—  
P21110-FCH-XX-XX-RP-A-0003  
PLANNING APPLICATION PROPOSED AMENDMENTS - OVERVIEW  
APPLICATION REF: 120149/FO/2018  
—

# Planning Application Proposed Amendments - Overview

Ducie Street,  
Manchester,  
M1 2JQ

Ground Floor Plan - Proposed Amendments 1:200

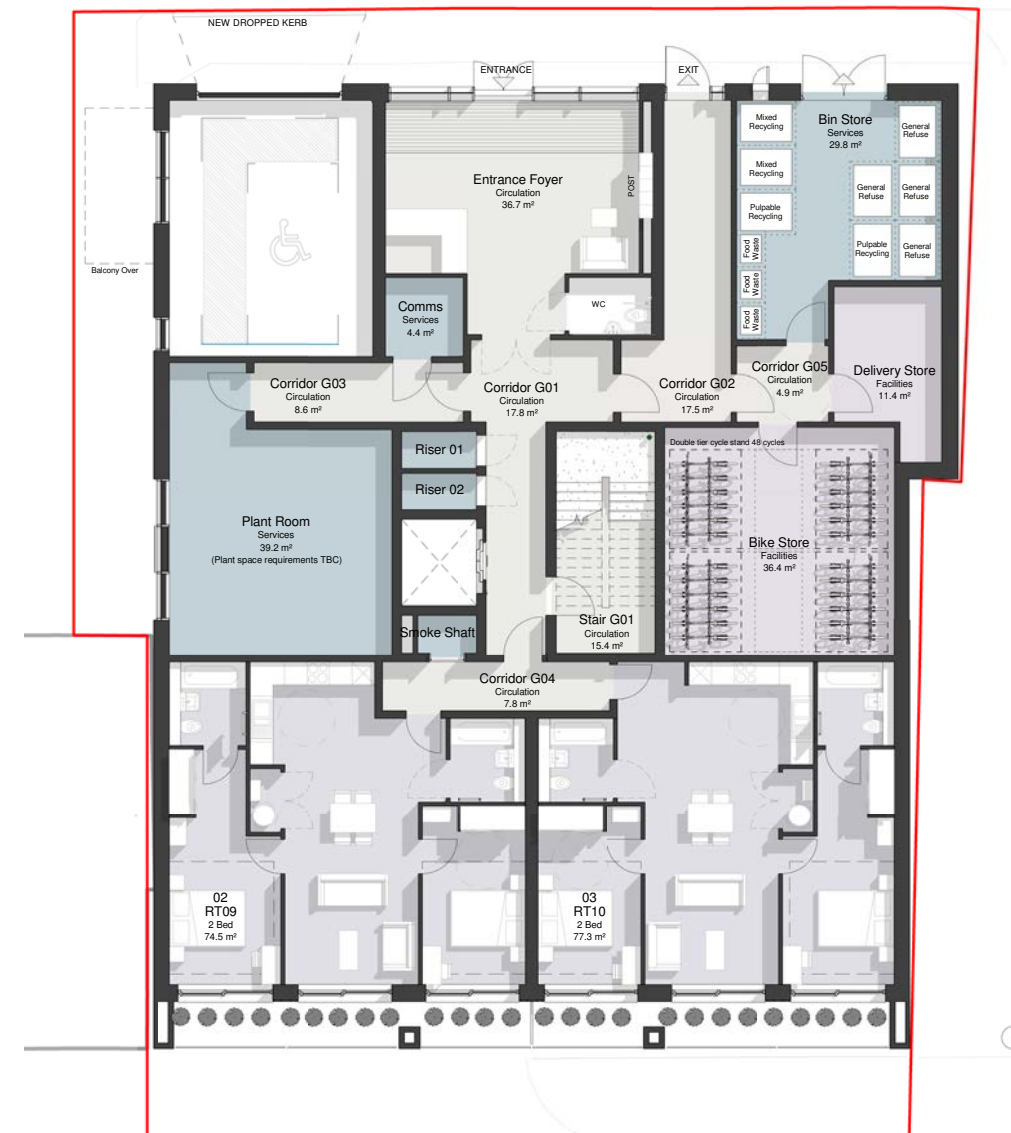
- 01. Change the balcony balustrades from frameless glass to metal railing to suit Building Regulation approval requirements.
- 02. Add collective edge Protection to Roof level.

- 03. Re-set out metal cladding panels to suit manufacturing constraints.
- 04. Amend roller shutter door, louvred panels and add new louvred door to suit internal layout amendments.

North West Elevation - Proposed Amendments 1:200

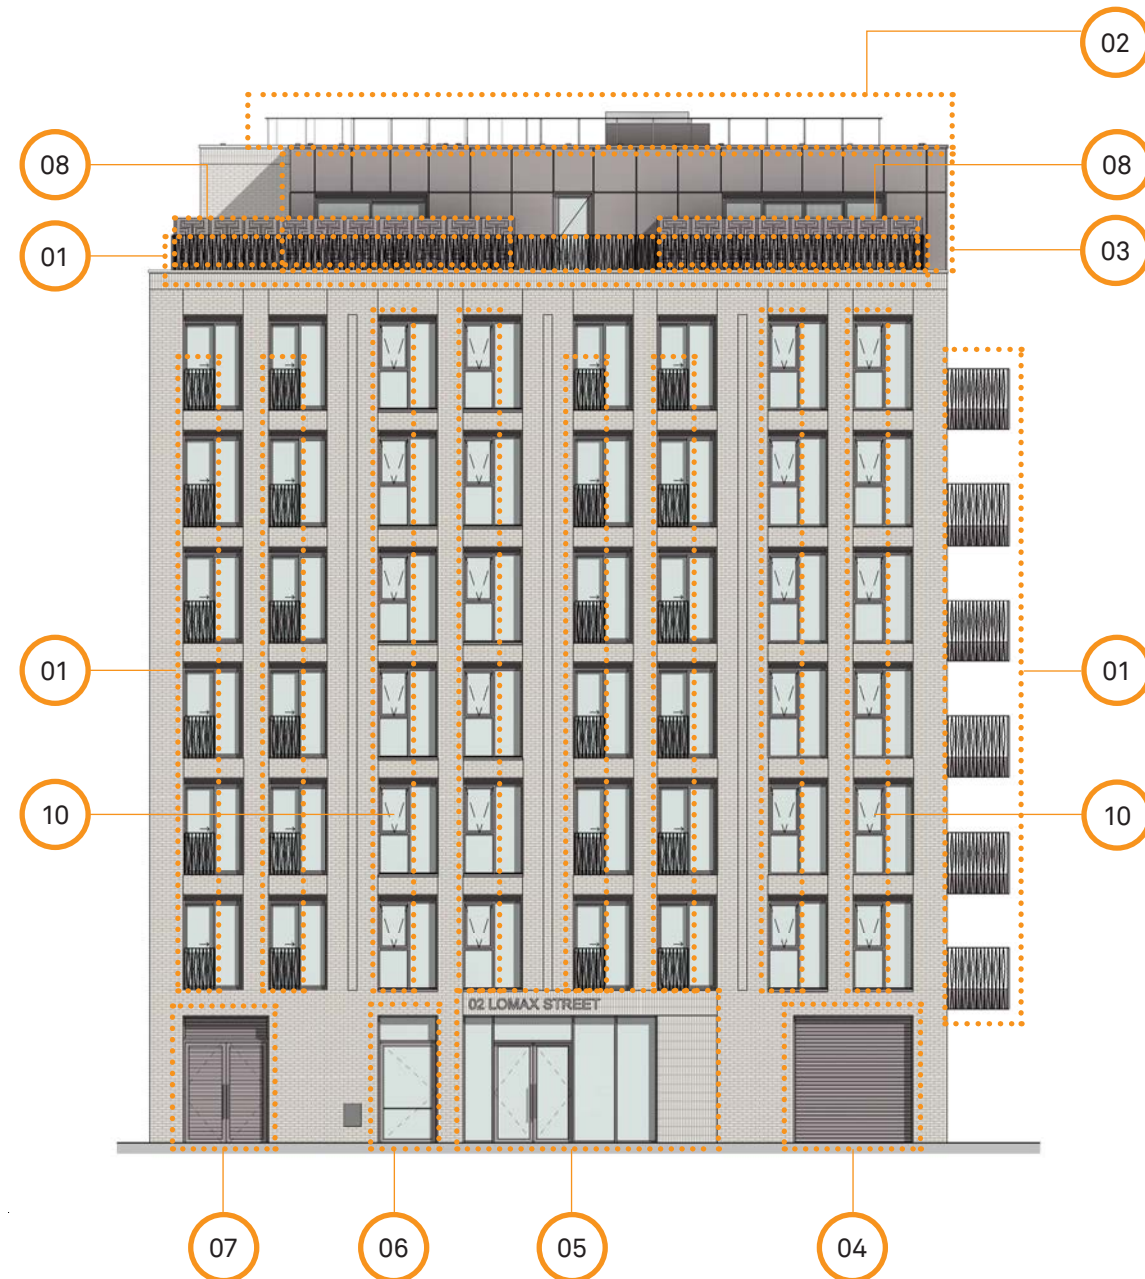
- 01. Change the balcony balustrades from frameless glass to metal railing to suit Building Regulation approval requirements.
- 02. Add collective edge Protection to Roof level.
- 03. Re-set out metal cladding panels to suit manufacturing constraints.

- 04. Amend roller shutter door, louvred panels and add new louvred door to suit internal layout amendments.
- 05. Revise entrance door and glazing on Lomax St elevation to suit to internal layout amendments.
- 06. Simplify the arrangement of the Glazed Fire Escape Door on Lomax St elevation.
- 07. Amend location of louvred doors to align opening with brick vertical movement joint reducing visual impact of the movement joint.
- 08. Split perforated panels on north-east & south-west elevations and roof privacy screens due to manufacturers limitations.
- 09. Minor adjustment to soldier course brick detail on West & East Elevations to suit masonry support limitations.
- 10. Change of window opening type to meet natural purge ventilation requirements on Lomax Street elevation.

North East Elevation - Proposed Amendments 1:200

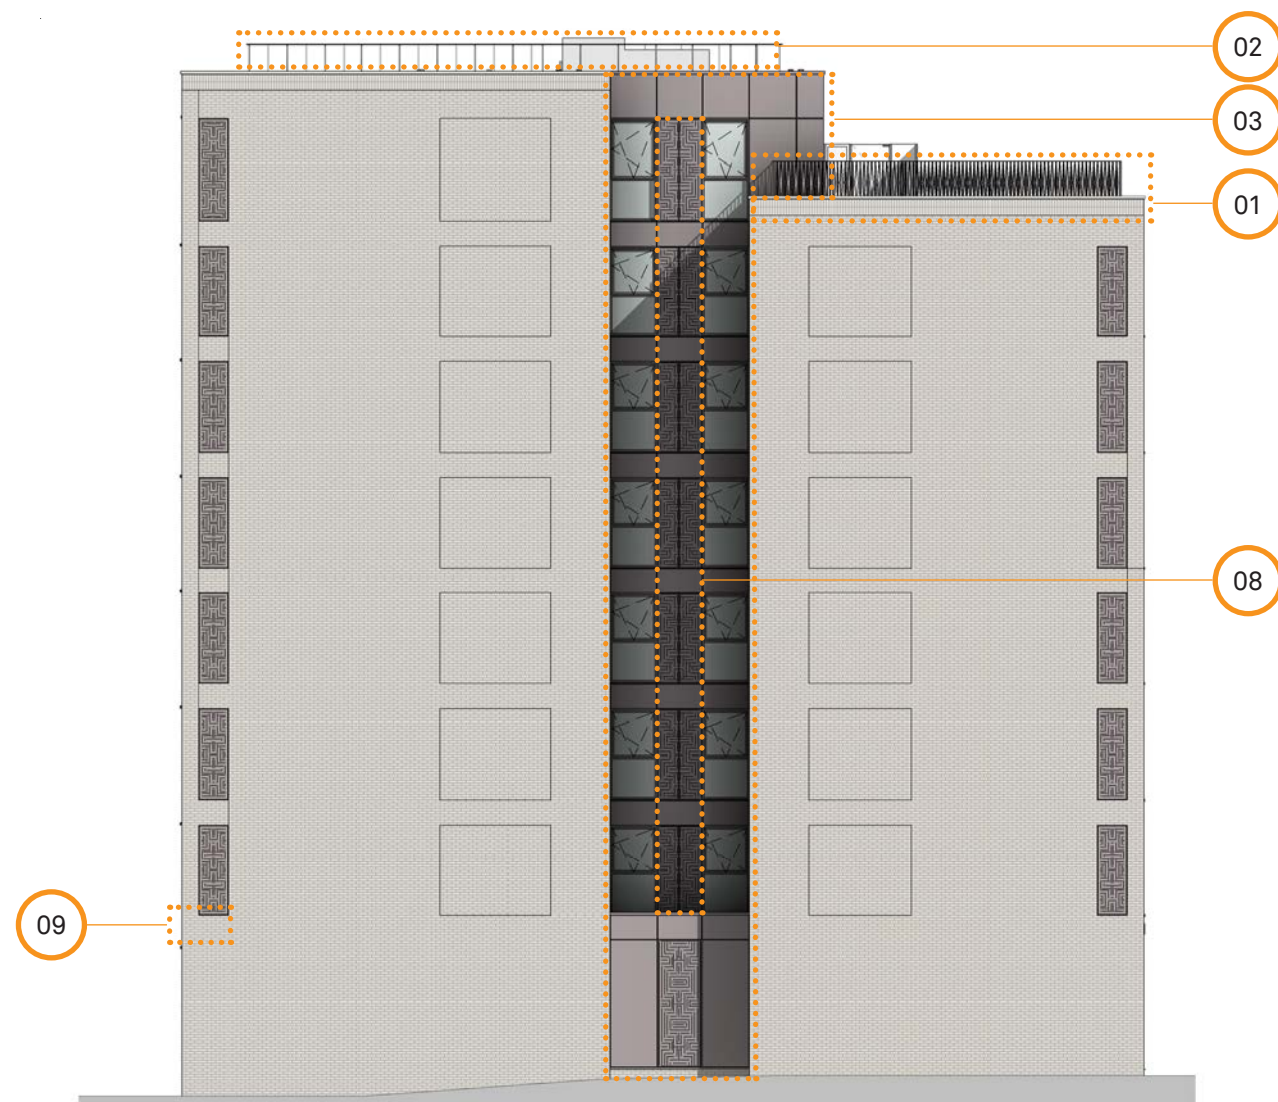
- 01. Change the balcony balustrades from frameless glass to metal railing to suit Building Regulation approval requirements.
- 02. Add collective edge Protection to Roof level.

- 03. Re-set out metal cladding panels to suit manufacturing constraints.
- 04. Amend roller shutter door, louvred panels and add new louvred door to suit internal layout amendments.

- 05. Revise entrance door and glazing on Lomax St elevation to suit to internal layout amendments.
- 06. Simplify the arrangement of the Glazed Fire Escape Door on Lomax St elevation.

- 07. Amend location of louvred doors to align opening with brick vertical movement joint reducing visual impact of the movement joint.
- 08. Split perforated panels on north-east & south-west elevations and roof privacy screens due to manufacturers limitations.

South East Elevation - Proposed Amendments 1:200

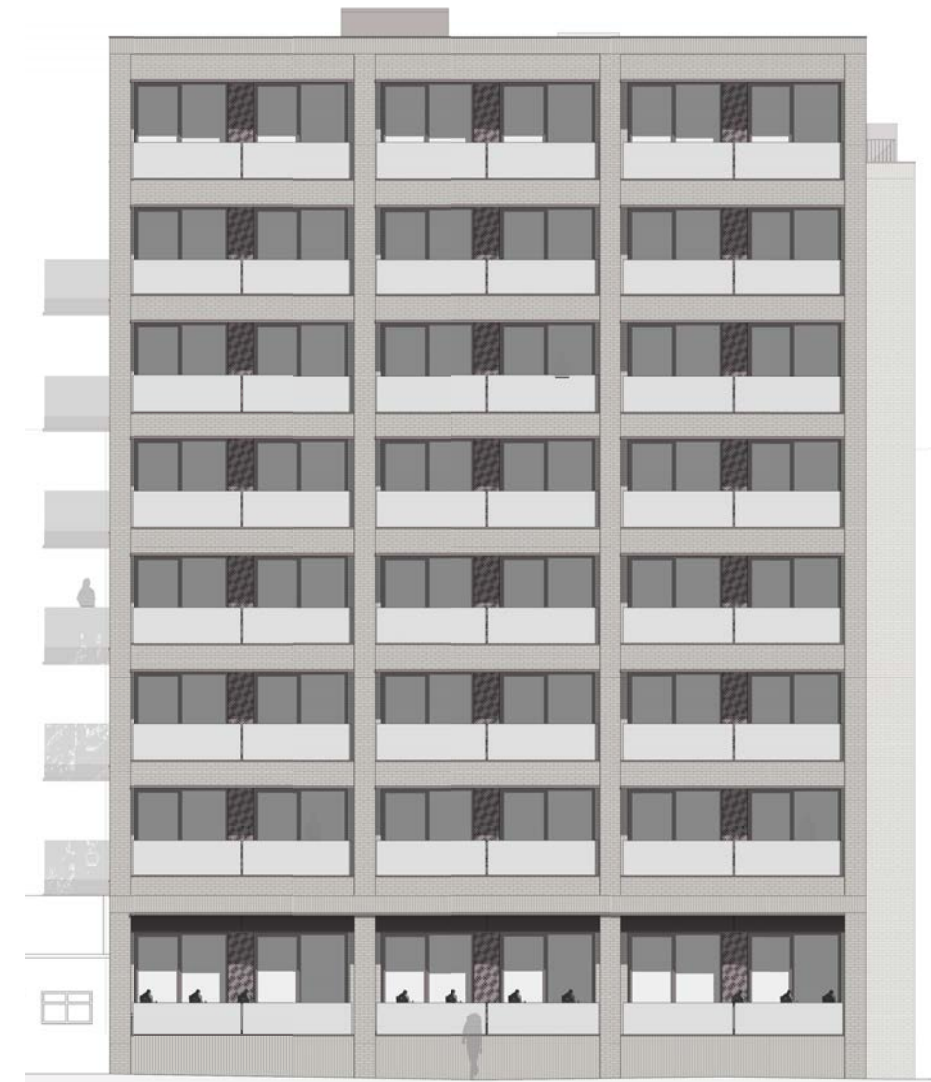
- 01. Change the balcony balustrades from frameless glass to metal railing to suit Building Regulation approval requirements.
- 02. Add collective edge Protection to Roof level.

- 03. Re-set out metal cladding panels to suit manufacturing constraints.
- 04. Amend roller shutter door, louvred panels and add new louvred door to suit internal layout amendments.

- 05. Revise entrance door and glazing on Lomax St elevation to suit to internal layout amendments.
- 06. Simplify the arrangement of the Glazed Fire Escape Door on Lomax St elevation.

South West Elevation - Proposed Amendments 1:200

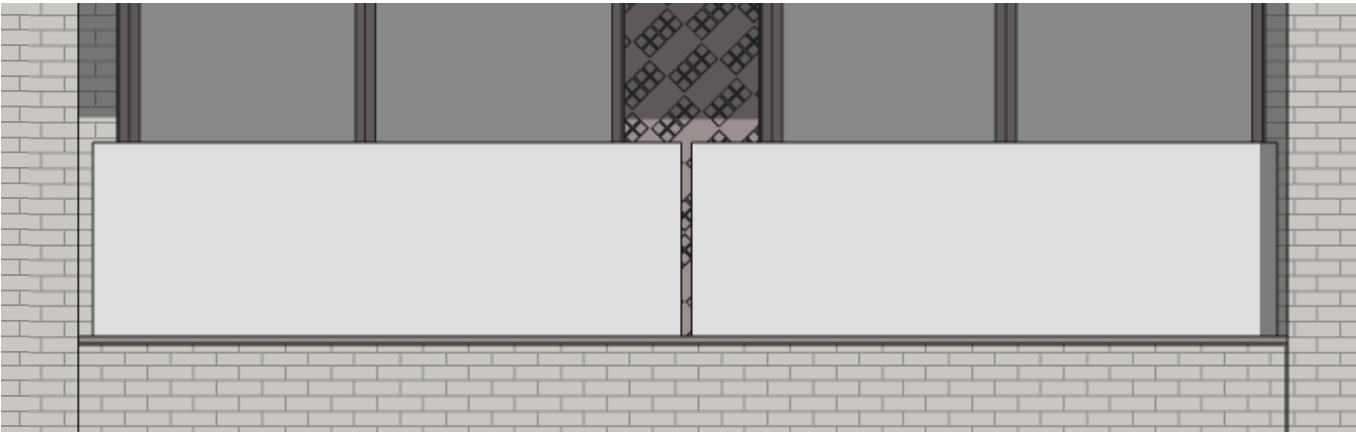
- 01. Change the balcony balustrades from frameless glass to metal railing to suit Building Regulation approval requirements.
- 02. Add collective edge Protection to Roof level.
- 03. Re-set out metal cladding panels to suit manufacturing constraints.

- 04. Amend roller shutter door, louvred panels and add new louvred door to suit internal layout amendments.
- 05. Revise entrance door and glazing on Lomax St elevation to suit to internal layout amendments.
- 06. Simplify the arrangement of the Glazed Fire Escape Door on Lomax St elevation.
- 07. Amend location of louvred doors to align opening with brick vertical movement joint reducing visual impact of the movement joint.
- 08. Split perforated panels on north-east & south-west elevations and roof privacy screens due to manufacturers limitations.
- 09. Minor adjustment to soldier course brick detail on West & East Elevations to suit masonry support limitations.
- 10. Change of window opening type to meet natural purge ventilation requirements on Lomax Street elevation.

01 BALCONY BALUSTRADE - DESIGN DEVELOPMENT

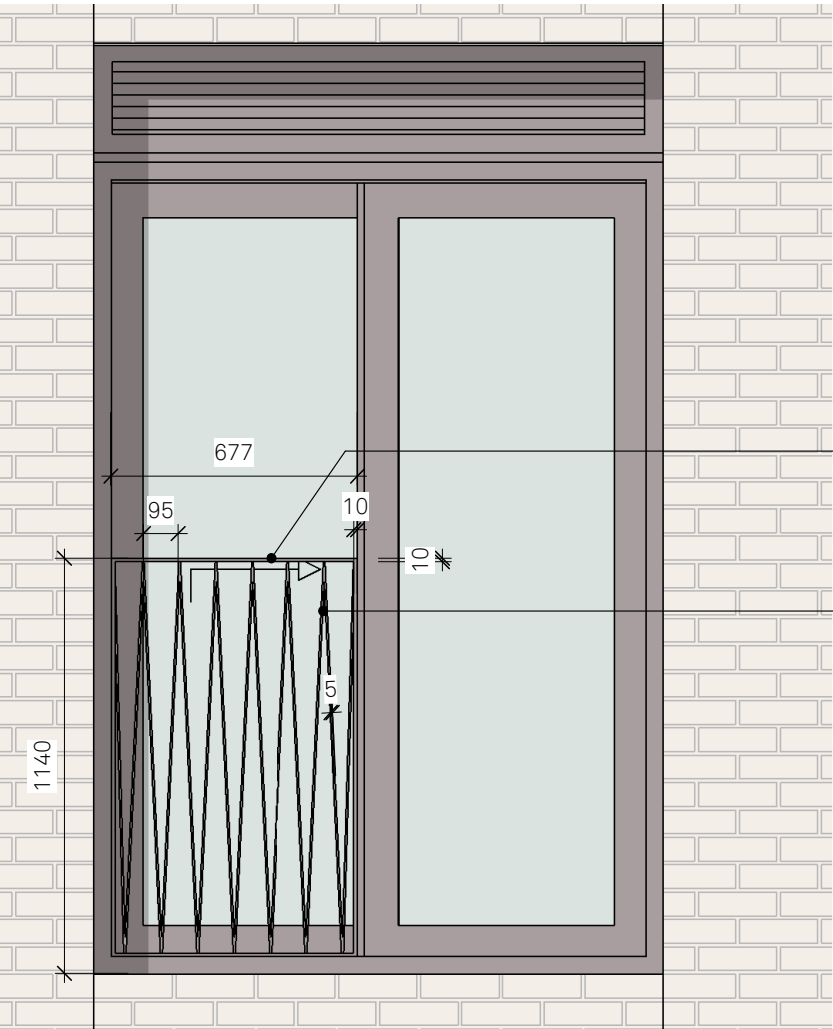
As the project developed, the BCO (Ball & Berry) were unable to advise that any glazed balustrade product would meet the criteria defined in Regulation 7 (fig. 01). Following these comments, the design team began looking at developing a metal balustrade solution for all balcony types.

The initial design of the metal railing was developed as a bespoke element, with thin circular rods to maximise visual transparency and give a lighter appearance, the same intent behind using glazed balustrades and also tie in with the textile theme used in motifs in the brick detailing and perforated metal panels.

However MCC felt this design was not bespoke enough and lacked variation across the building.

### Developed Design (Metal Balustrade)

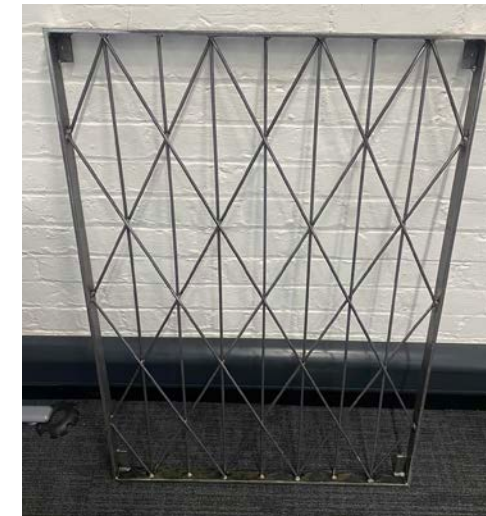
Of the options developed, the one below was preferred as it balanced the detail and decoration without overloading the buildings appearance and possessed a more direct reference to the diamond motive.

However, the Principal Designer (CDM) consultant advised that the design was considered climbable and therefore presented a risk. After this, we looked to develop another option which incorporated the PD's comments.

### Proposed Metal Balustrade Design

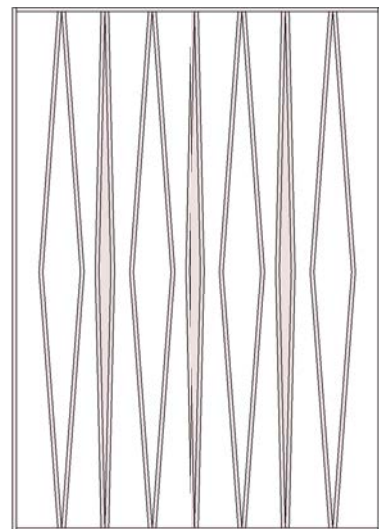
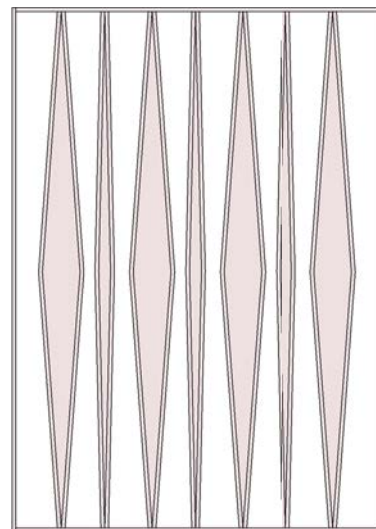
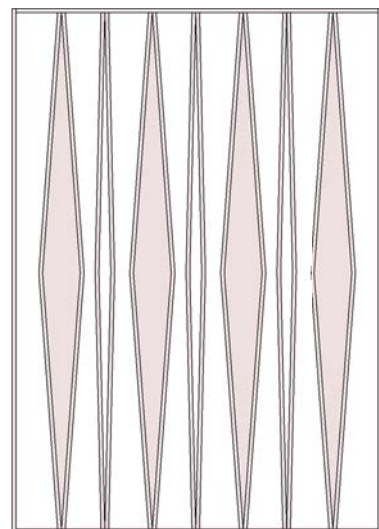
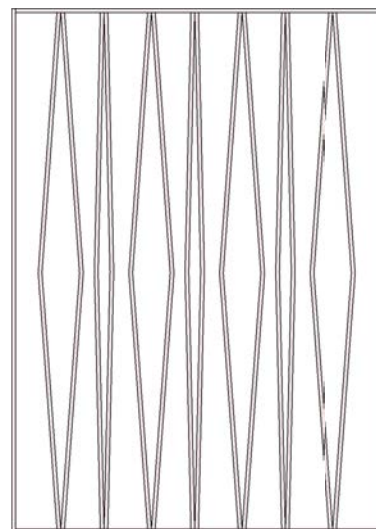
We developed the proposed balustrade design below, which took onboard comments from the PD(CDM) consultant but balanced the previous planning comments regarding variation across the building. As part of the bespoke nature, four railing types were developed, utilising the same baluster designs but varying the use of infill panels across the balcony types and elevations.

On 16.07.24 FCH presented the updated balustrade design to MCC and the design was accepted in principle.

## 02 PERMANENT EDGE PROTECTION TO ROOF LEVEL

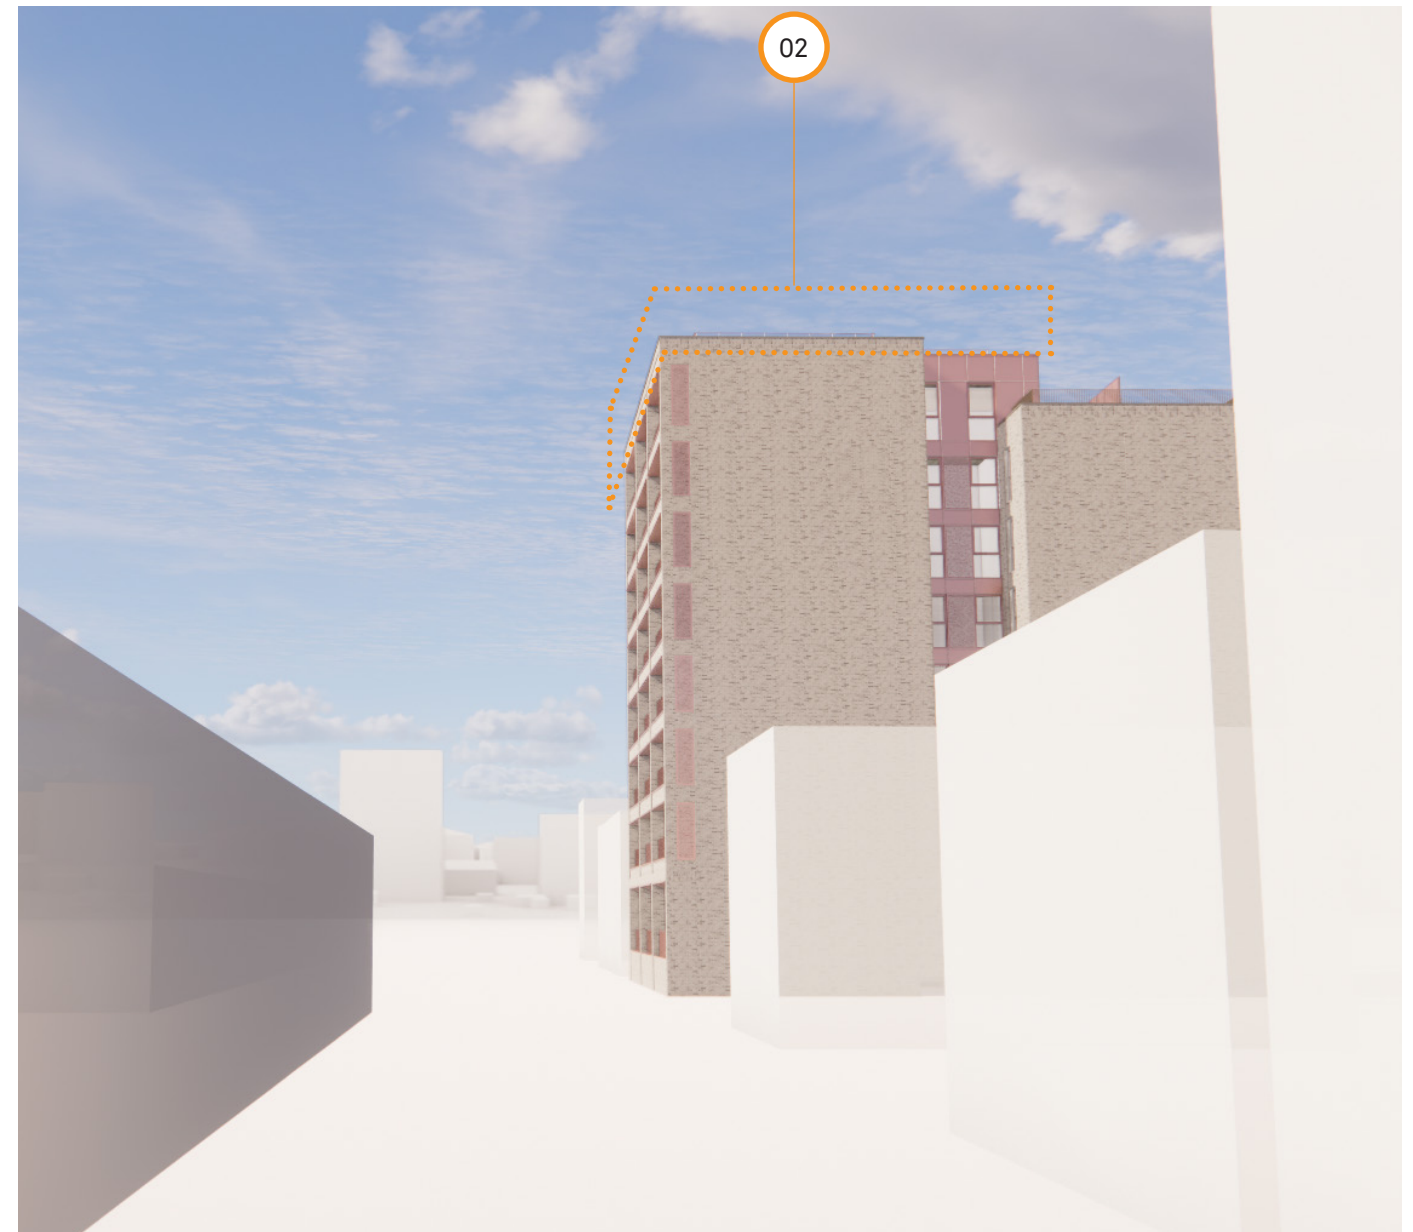
With reference to the 'Hierarchy of Risk Reduction Measures' provided by the HSE, a collective measure such as a balustraded rail would be less susceptible to human error and therefore safer than an individual protection system such as the man-safe or running line system suggested in the Approved Design and Access Statement.

Whilst the balustraded rail is visible on the elevations, it has been set back from the roof edge so that when the building is seen from street level the rails should mostly not be visible or are only minimally visible. This should have no impact on the overall appearance of the building.

Illustrative views from street level indicating the visibility of the permanent edge protection on the roof level.
